Subject: Westinghouse Owners Group
Transmittal of Approved Topical Report, WCAP-15603, Rev. 1-A, (Non-Proprietary) "WOG 2000 Reactor Coolant Pump Seal Leakage Model for Westinghouse PWRs" (MUHP-6074)

**WOG 2000
REACTOR COOLANT PUMP SEAL
LEAKAGE MODEL FOR
WESTINGHOUSE PWRS**

**SUBJECT: SAFETY EVALUATION OF TOPICAL REPORT WCAP-15603, REVISION 1,
"WOG 2000 REACTOR COOLANT PUMP SEAL LEAKAGE MODEL FOR
WESTINGHOUSE PWRs" (TAC NO. MB1714)**

WOG-2000 - WOG 2000 RCP Seal Leakage Model (as modified by SER)

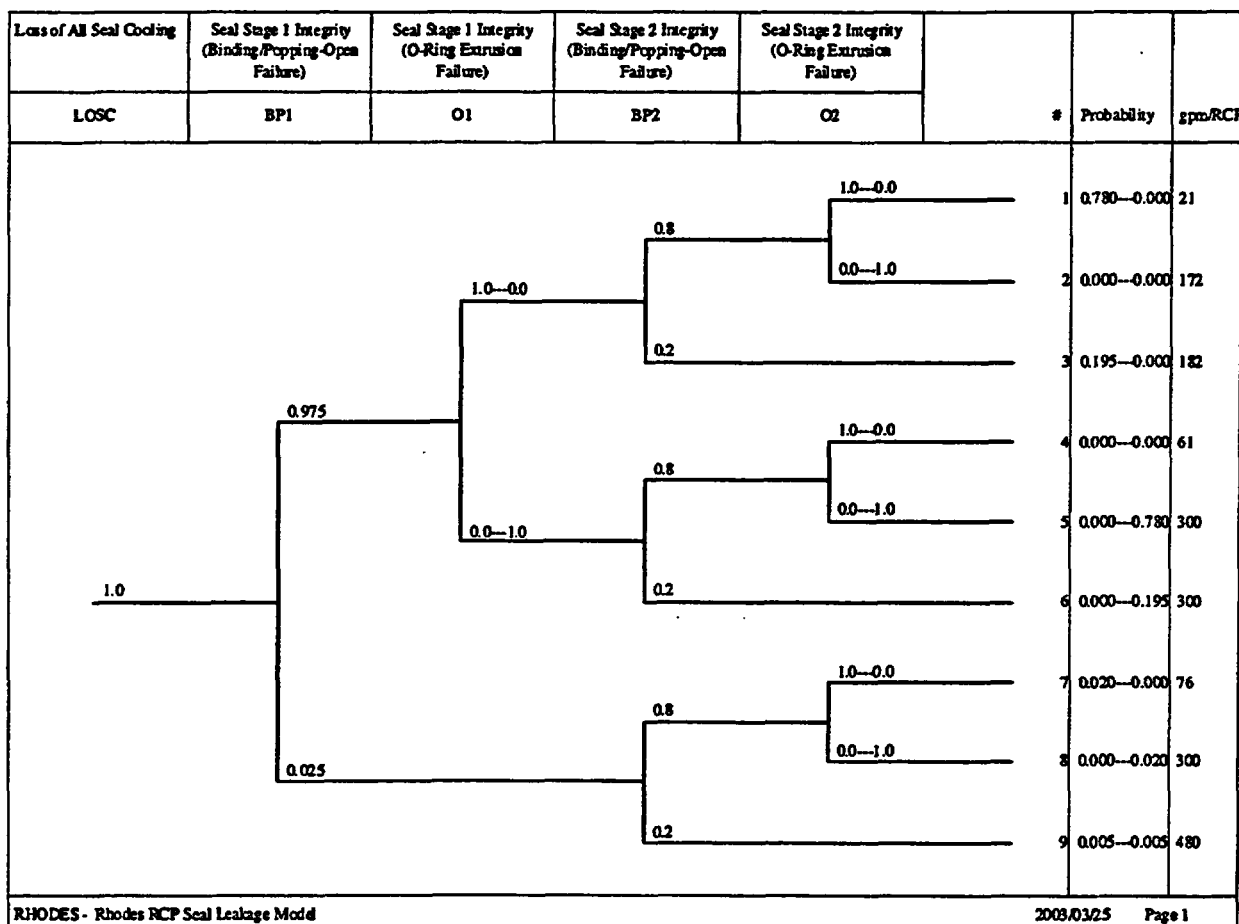
For the first 13 minutes after the loss of all seal cooling, the leakage rate is 21 gpm (i.e., Sequence 1 with a probability of unity). The probability of O-ring extrusion failure is zero for the high-temperature O-rings, as long as the plant cooldown will result in a RCS pressure less than 1710 psi within 2 hours. Thus, under these conditions after the first 13 minutes, the leakage rate is as provided in the figure above with the associated sequence probabilities. If the plant cooldown will not result in an RCS pressure less than 1710 psi within 2 hours, then extrusion failure of the O-rings must be addressed with a failure probability of 0.5 for the high-temperature O-rings.

For the first 13 minutes after the loss of all seal cooling, the leakage rate is 21 gpm/RCP (i.e., Sequence 1 with a probability of unity). The probability of O-ring extrusion failure is zero for the first two hours, but is unity after the first two hours. Therefore, after the first 13 minutes and up to 2 hours, the leakage rate is as provided in the figure above with the first probability value given in the figure. After 2 hours, the leakage rate is as provided in the figure above with the second probability value given in the figure.

Figure 2.2-1 Event Tree for RCP Seal Leakage Scenarios

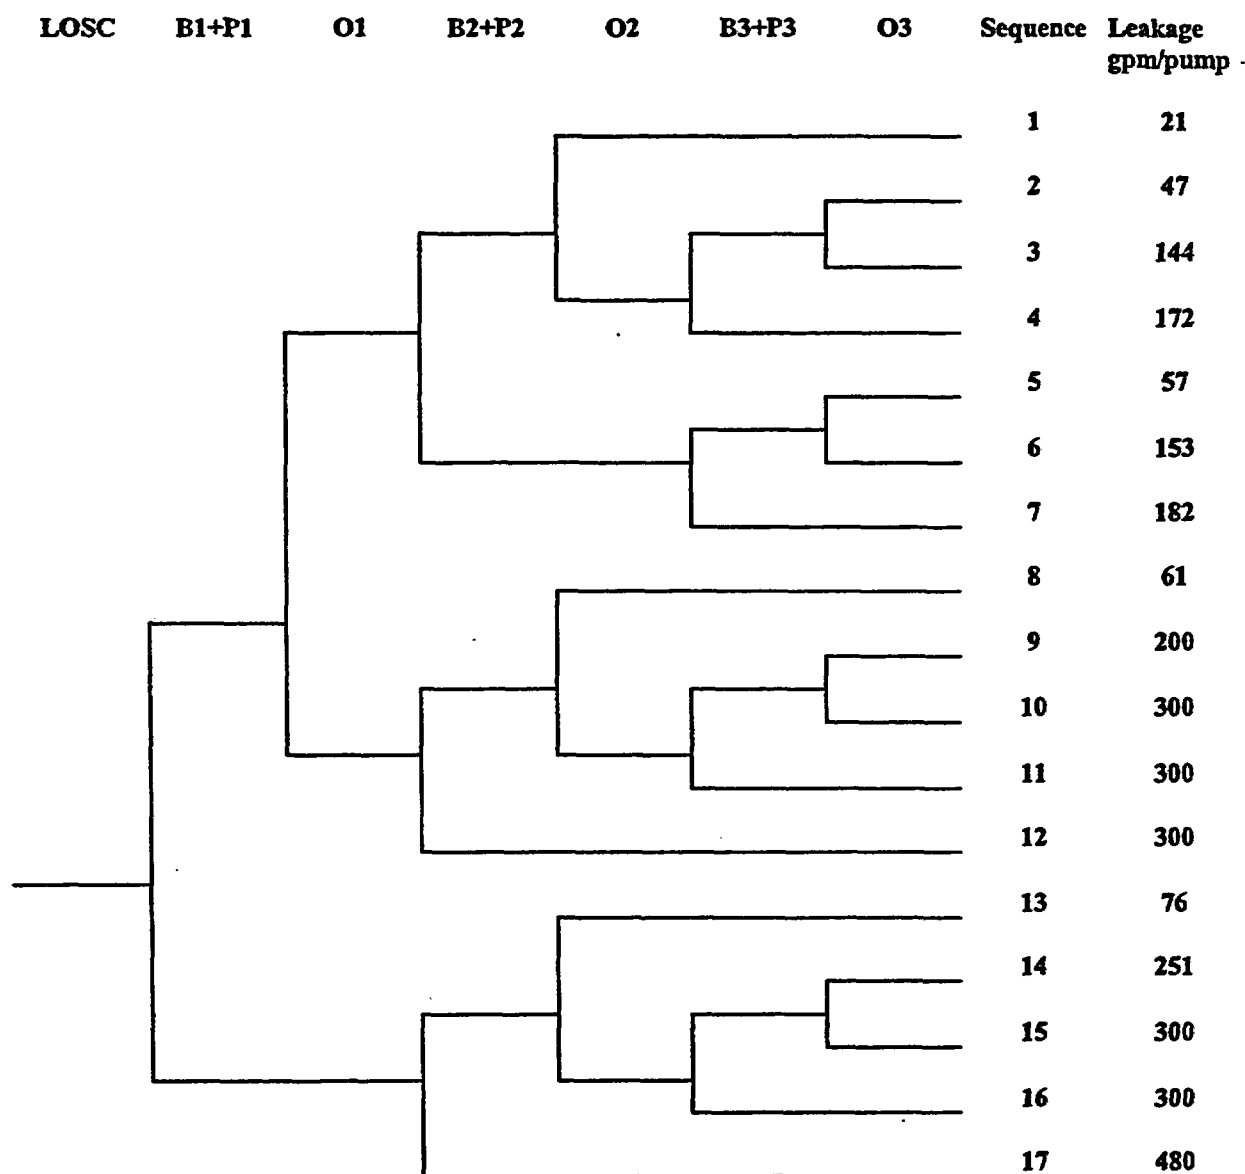
RAI 8 The Chapter 4 discussion and results are not fully consistent with the RCP seal leakage event tree model presented in Figure 2.2-1. To be consistent with the Chapter 4 tables, there should be branch points in Figure 2.2-1 under the B3+P3 for each scenario path. Specifically, Scenarios 1 and 13 should be split to represent success or failure of the B3+P3 branch. This condition is reflected in the WOG 2000 model tables for the period, t , greater than or equal to 0.5 hours, but less than 2 hours. Likewise, Scenario 12 should be split to reflect " t " greater than or equal to 2 hours, but less than 4 hours. For " t " greater than or equal to 4 hours, Scenario 12 should be split further, for the B3 + P3 success branch previously split, under the O3 branch. Further, the associated scenario leakage rates need to be established for each of these additional scenarios. The leakage rates for Scenarios 1b and 13b (failure of B3 +P3) need to be established or justified as remaining at the rate for the success path. Likewise, the leakage rates for Scenarios 12a (success of B3 + P3) and 12b (failure of B3 + P3) need to be established or justified. This justification is needed because these branches come from Scenarios 5 and 7, respectively, which have different leakage rates of 57 gpm and 182 gpm, respectively. Finally, the leakage rate for Scenario 12aa (success of B3 + P3 and O3) needs to be established. Should the rate be 251 gpm (similar to Scenario 14 conditions) or 300 gpm?

Response to RAI 8:

Chapter 4 of WCAP-15603 deals exclusively with old o-rings. All domestic Westinghouse nuclear power plants have either switched to qualified o-rings, or are scheduled to do so in the near future. Since the old o-rings are no longer used, we have removed reference to old o-rings from WCAP-15603. For any plants with old o-rings, this will be handled on a case-by-case basis.
